ADDENDUM No.2  
for  
INVITATION FOR BID (IFB)

BLUEBERRY HILL ELEMENTARY SCHOOL LAWN  
IRRIGATION

TOWN OF LONGMEADOW  
MASSACHUSETTS

July 13, 2018

**1. Detail on Electrical Panel Location and Wall Location for Water Line Installation:**

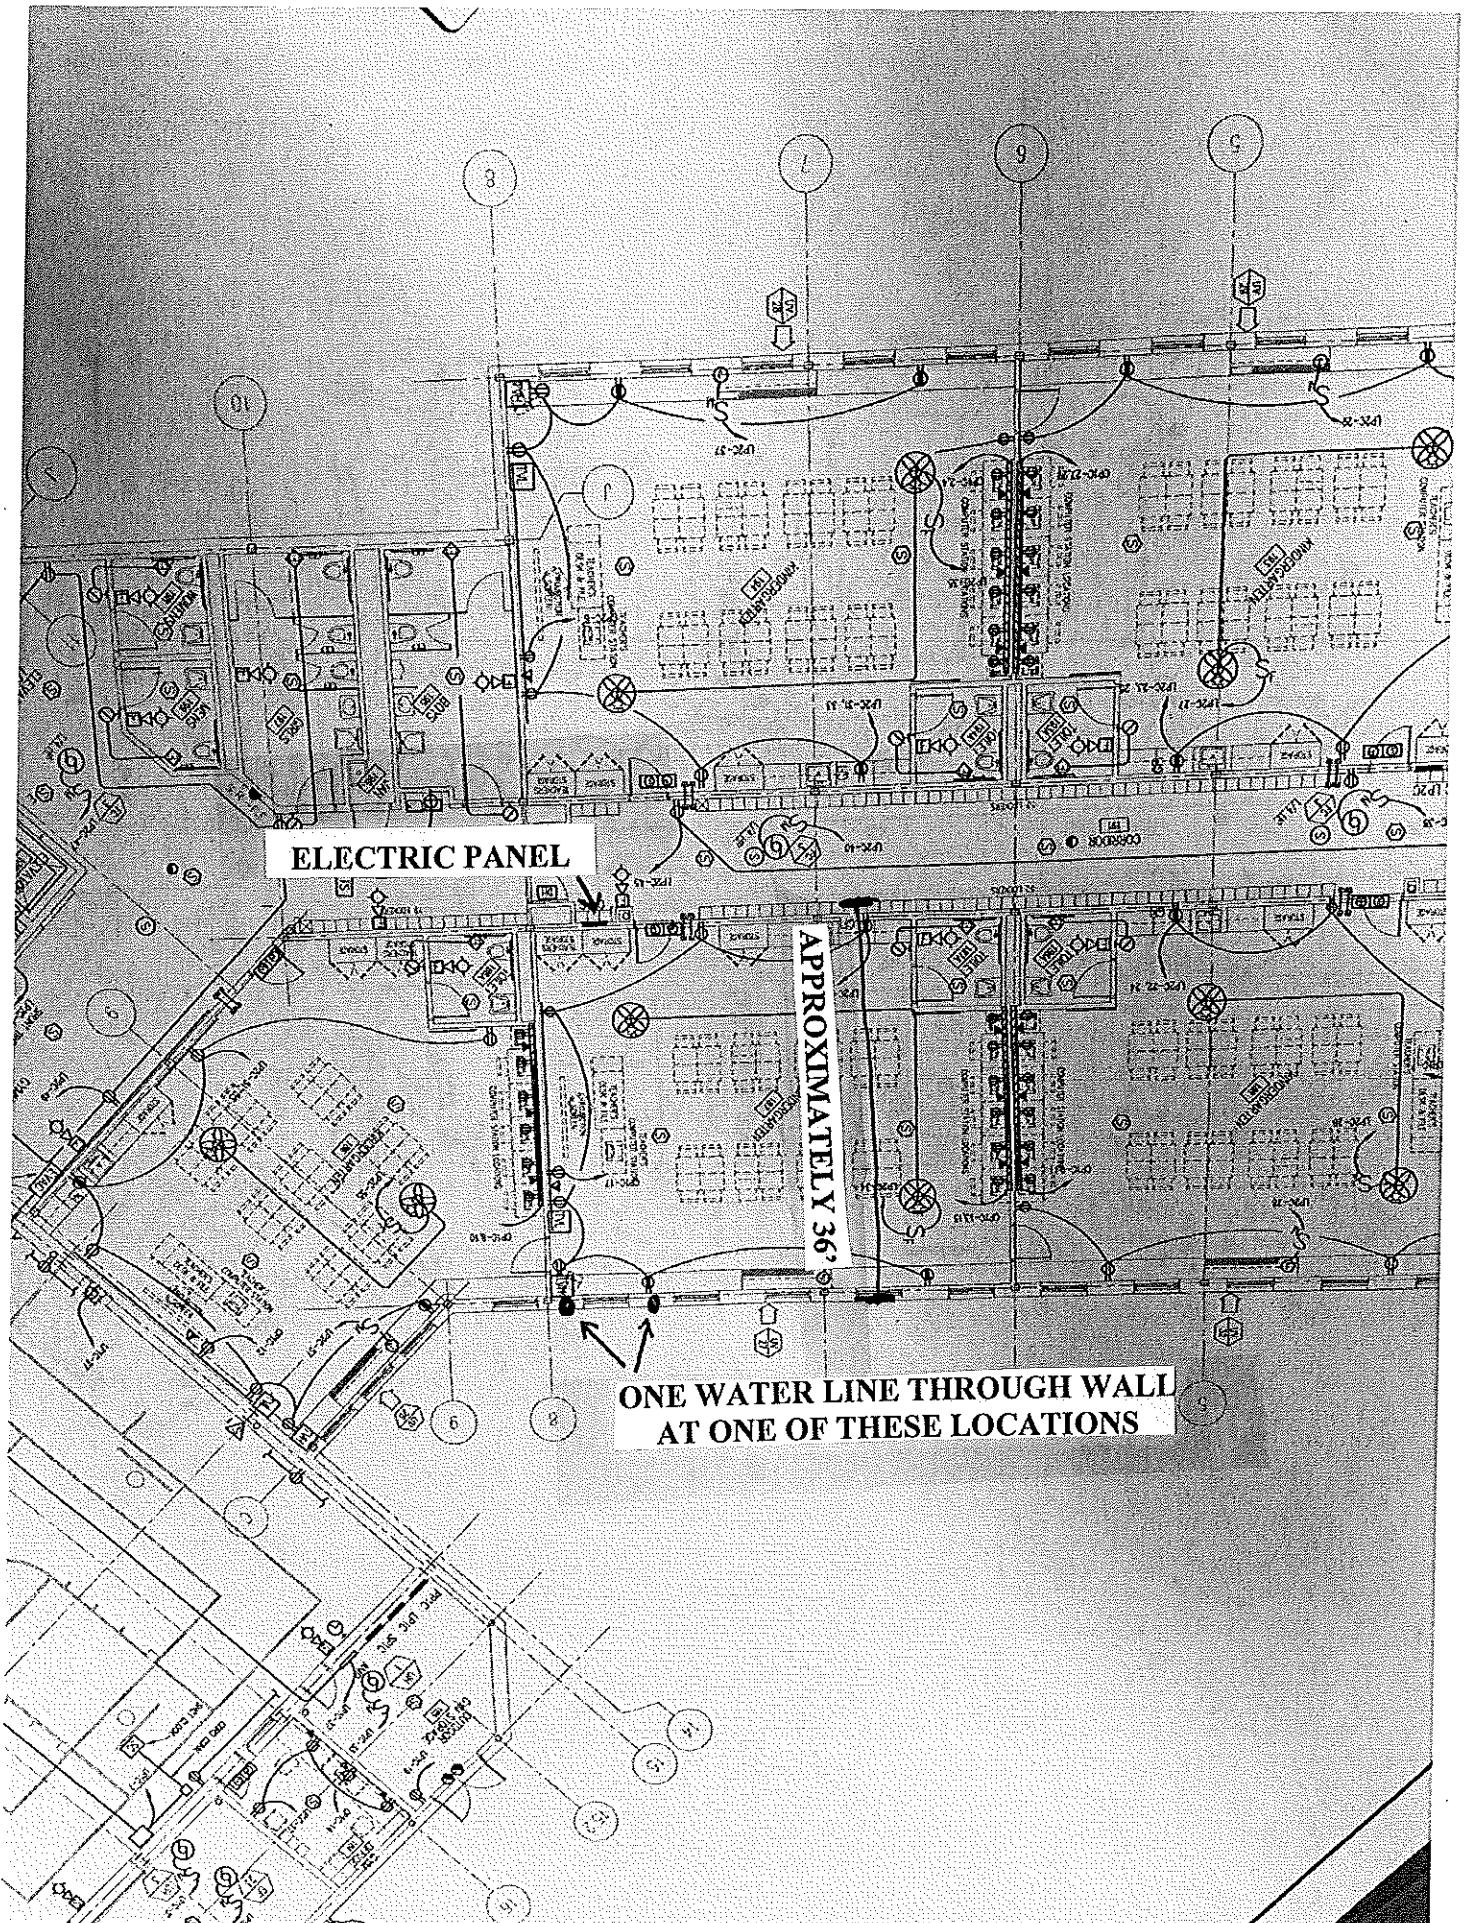
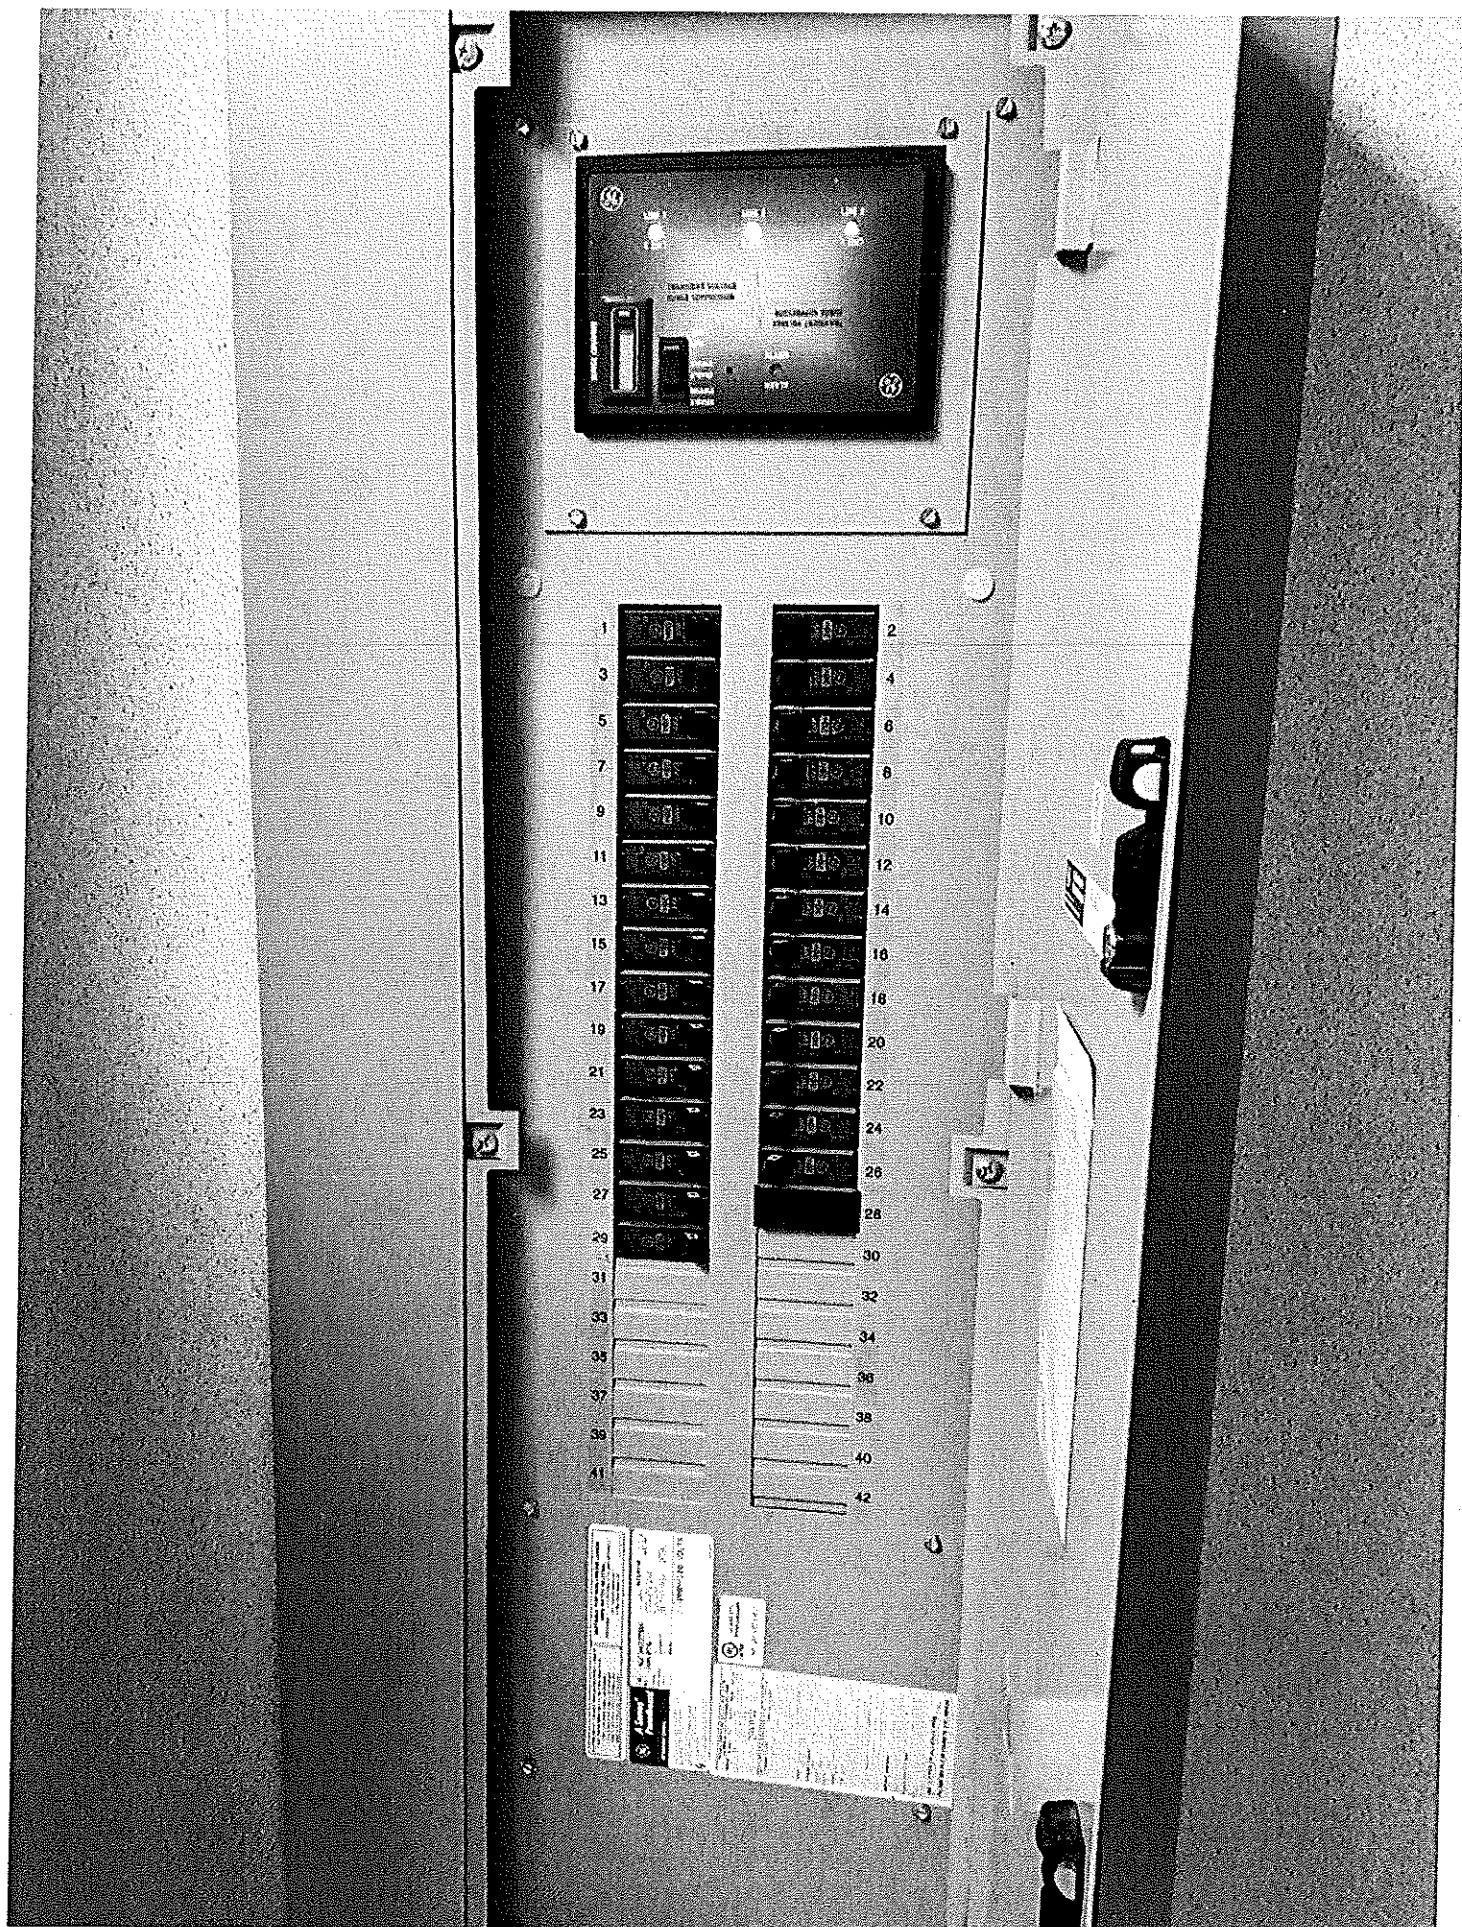
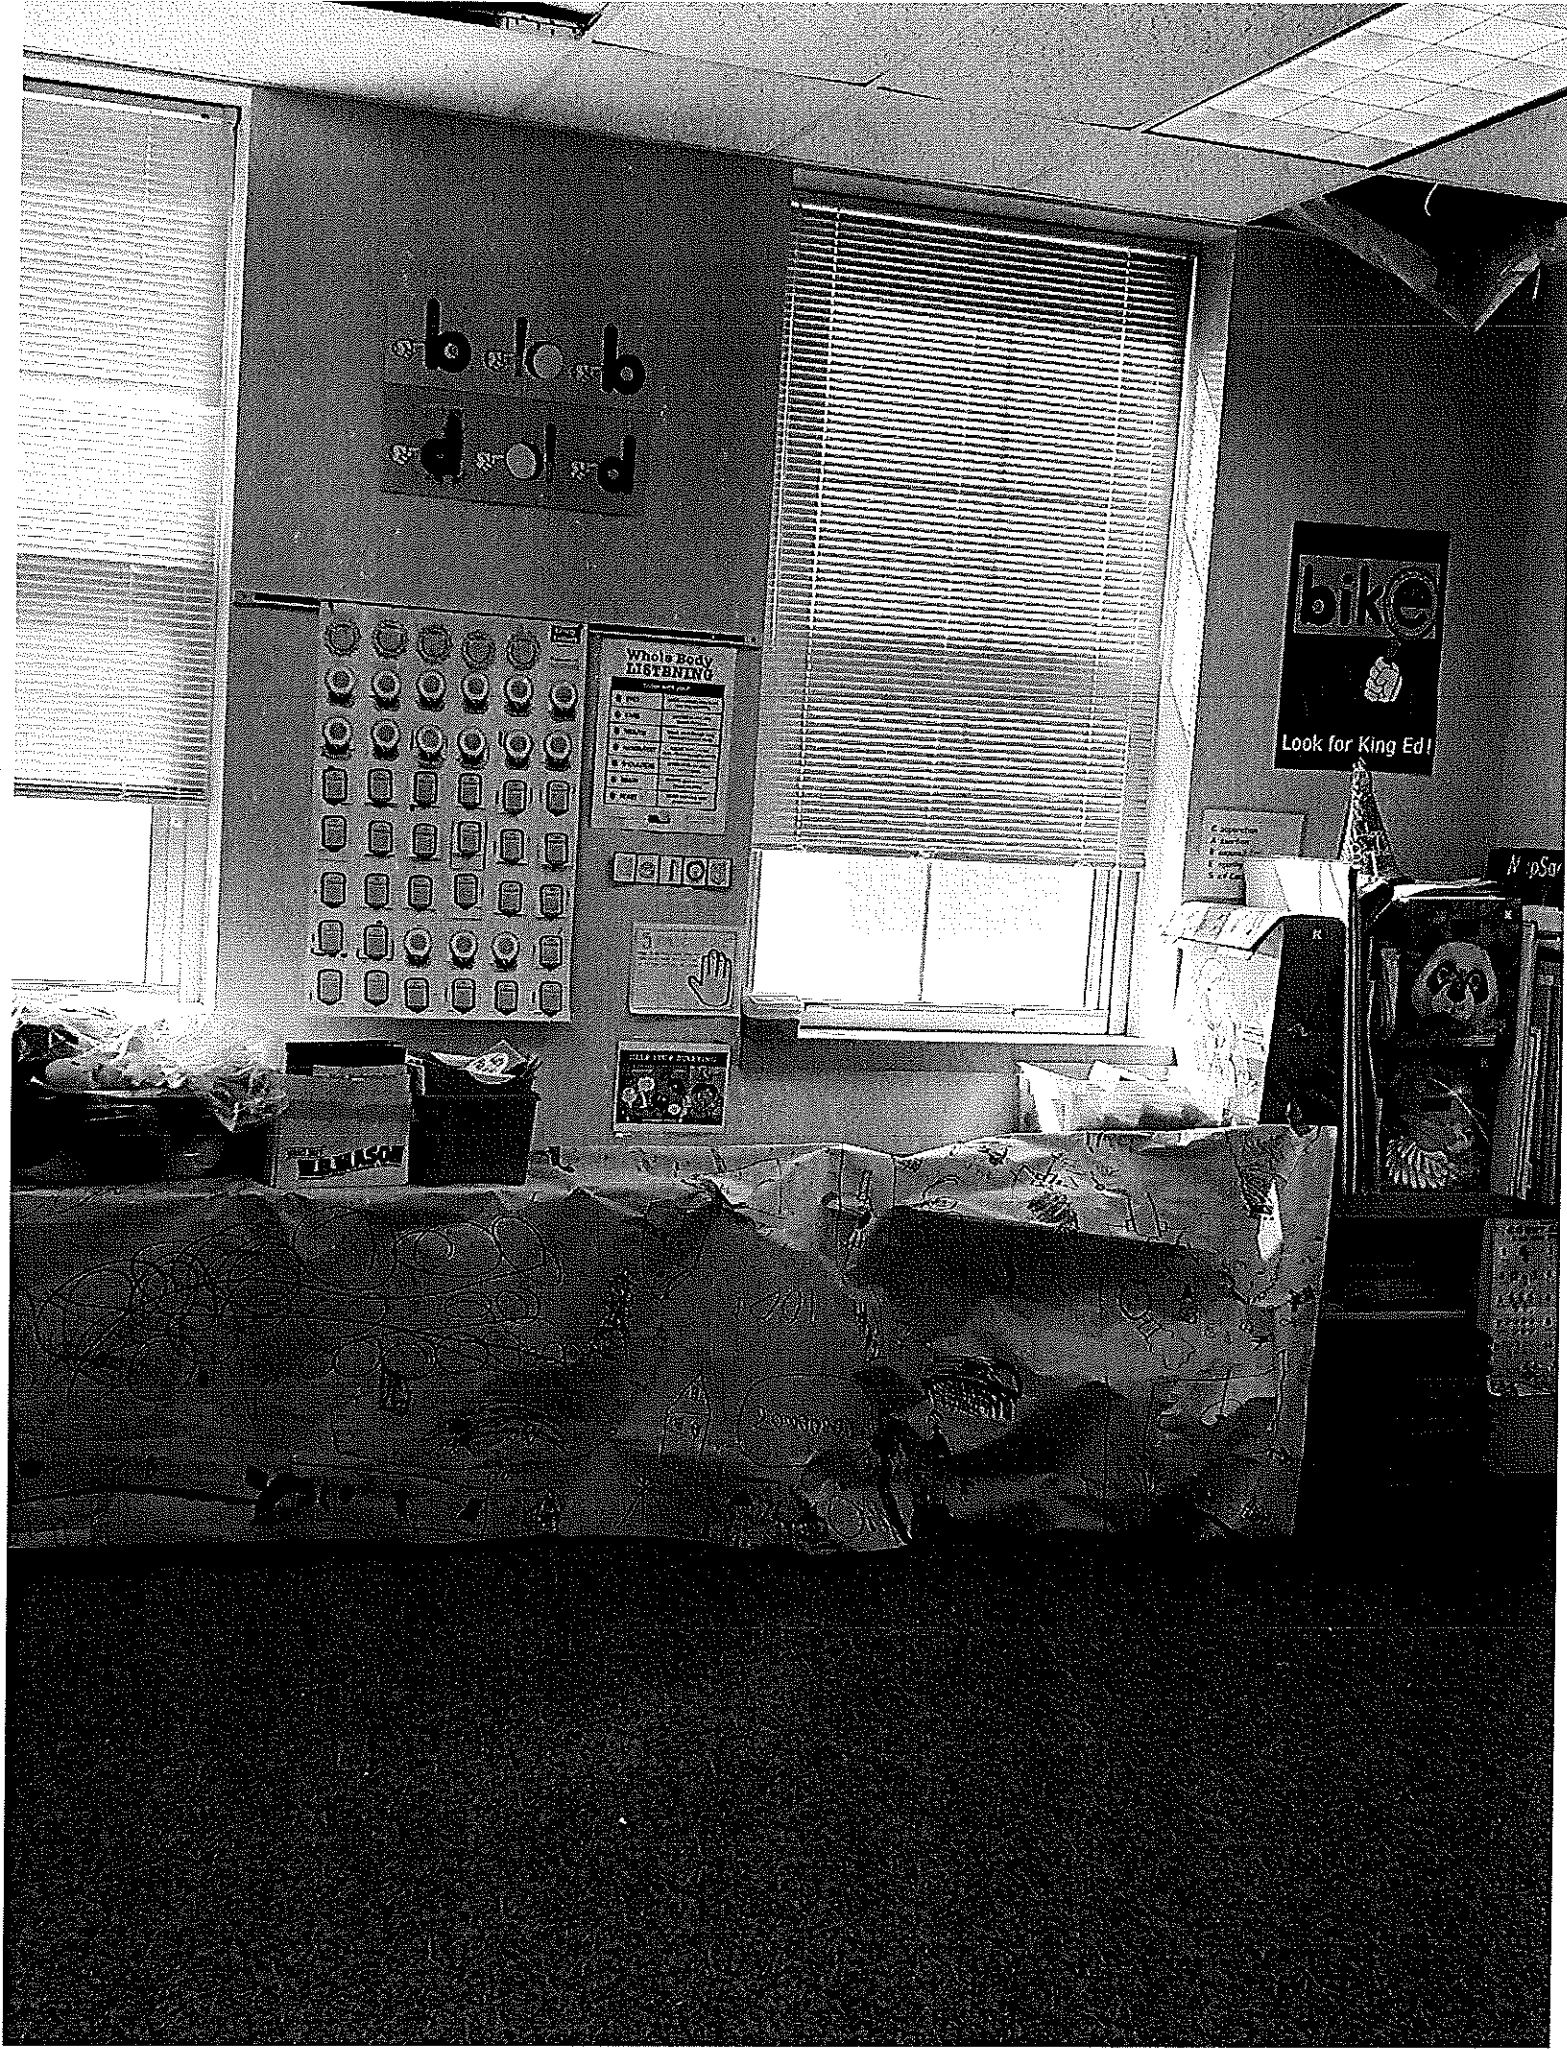
Provided are photos and plans that show the location of the electrical panel and the location where the installed water line will exit the building. The water shut off will be in the ceiling around the area above the electrical panel. The approximate distance of the water line to be installed in the ceiling is approximately 36’.
